UNITED STATES PATENT AND TRADEMARK OFFICE

Office Action Summary	Application No. 10/575,191	Applicant(s) WADA, SHIZUO	
	Examiner Fannie Kee	Art Unit 3679

DETAILED ACTION

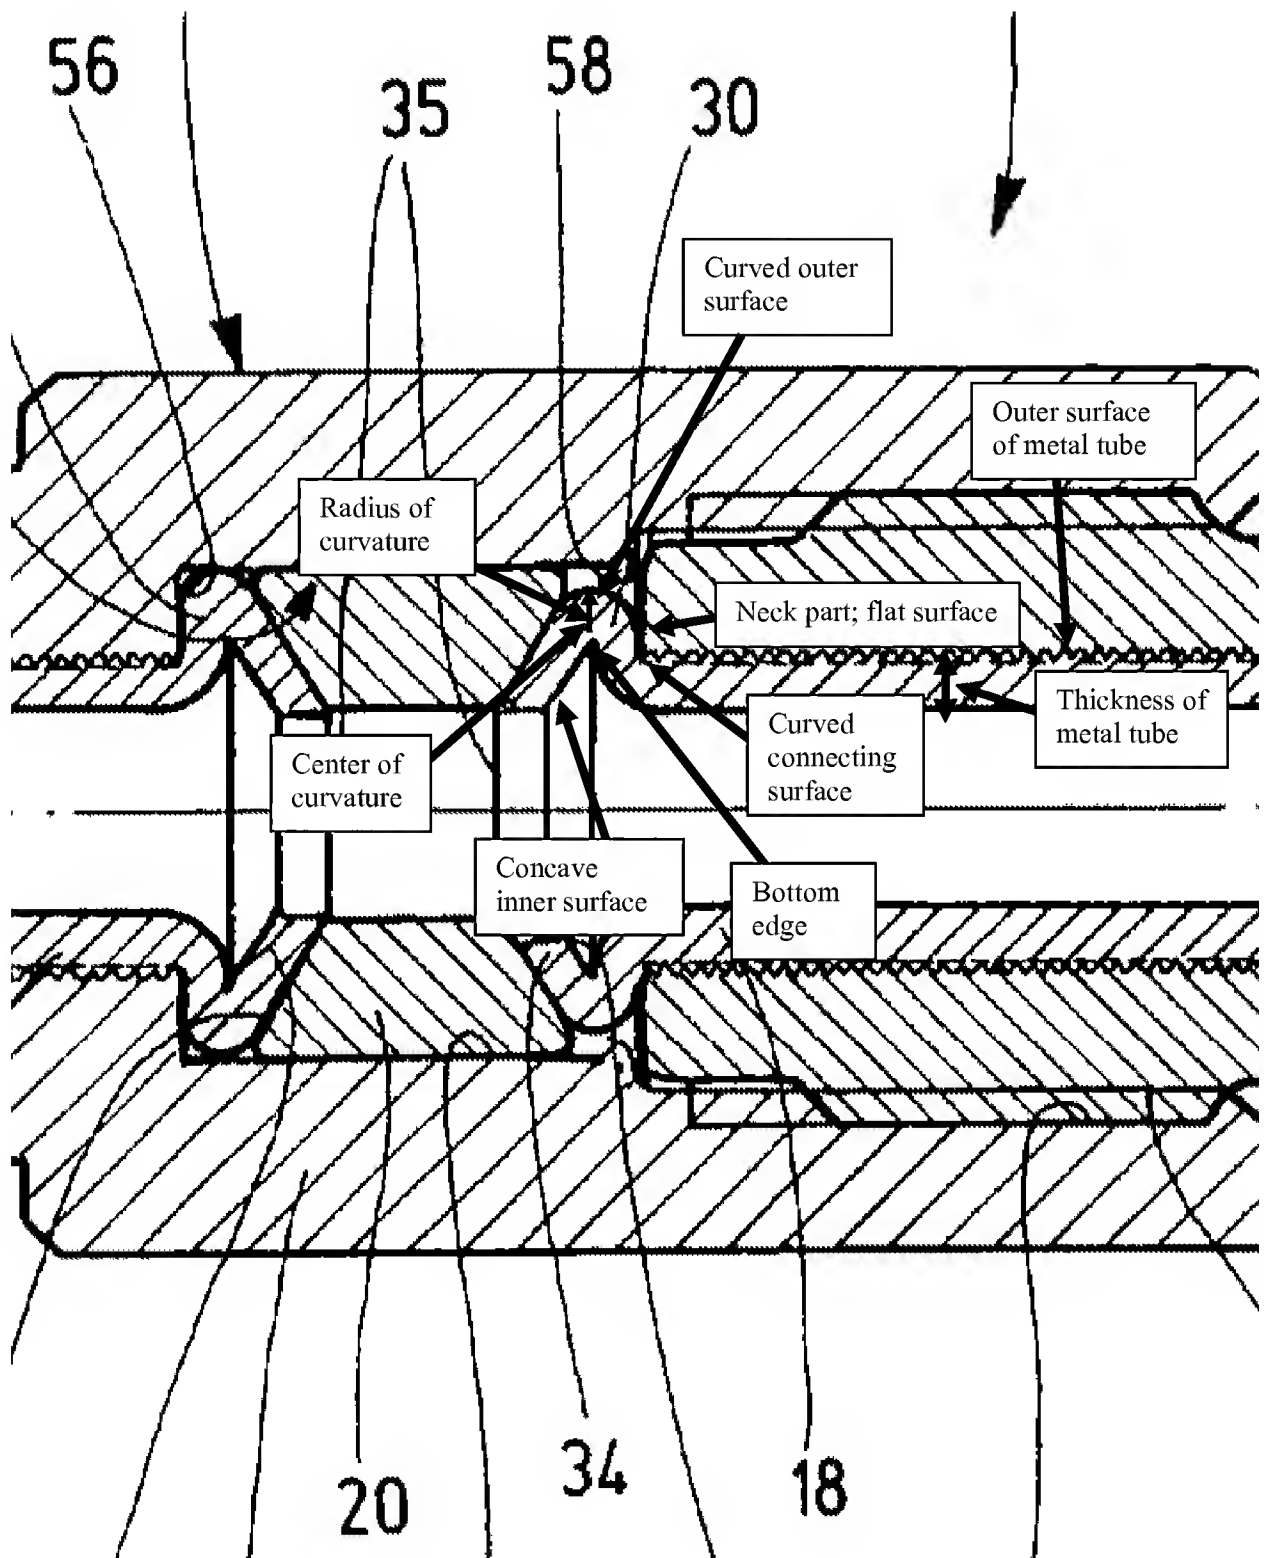
With regard to claim 1, and as seen in the figure below, Stahn et al disclose a flared end structure of a metal tube to be pressed against a seat formed in a member by tightening a coupling nut to the member, said flared end structure having a joining end part **(34)** to be pressed against the seat of the member, and a curved part **(30)** continuous with the joining end part;

wherein the curved part **(30)** has a curved outer surface with respect to the axis of the tube and a concave inner surface having a bottom edge, and

the curved outer surface has a radius R of curvature smaller than a wall thickness t of the metal tube so as to increase the rigidity of the flared end structure.

With regard to claim 2, and as shown in the figure above, Stahn et al disclose a flared end structure of a metal tube to be pressed against a seat formed in a member by tightening a coupling nut to the member having a joining end part **(34)** to be pressed against the seat of the member, and a curved part **(30)** continuous with the joining end part;

wherein the curved part **(30)** has a curved outer surface with respect to the axis of the tube and a concave inner surface having a bottom edge, and

the curved outer surface has a center of curvature at a position on the radially outer side of the bottom edge of the concave inner surface with respect to the axis of the tube so as to increase a rigidity of the flared end structure.

With regard to claim 3, and as shown in the figure above, Stahn et al disclose the curved outer surface merging into a flat surface, on which a coupling nut exerts pressure, of a neck part, and the bottom edge of the concave inner surface is in a radial range corresponding to the flat surface of the neck part.

With regard to claim 4, and as shown in the figure above, Stahn et al disclose the flat surface of the neck part being perpendicular to the axis of the tube.

With regard to claim 5, and as shown in the figure above, Stahn et al disclose the flat surface of the neck part being connected to the outer surface of the metal tube by a curved connecting surface having a center of curvature at a position radially outside the metal tube, and

the flat surface extends between the curved outer surface of the curved part and the curved connecting surface.
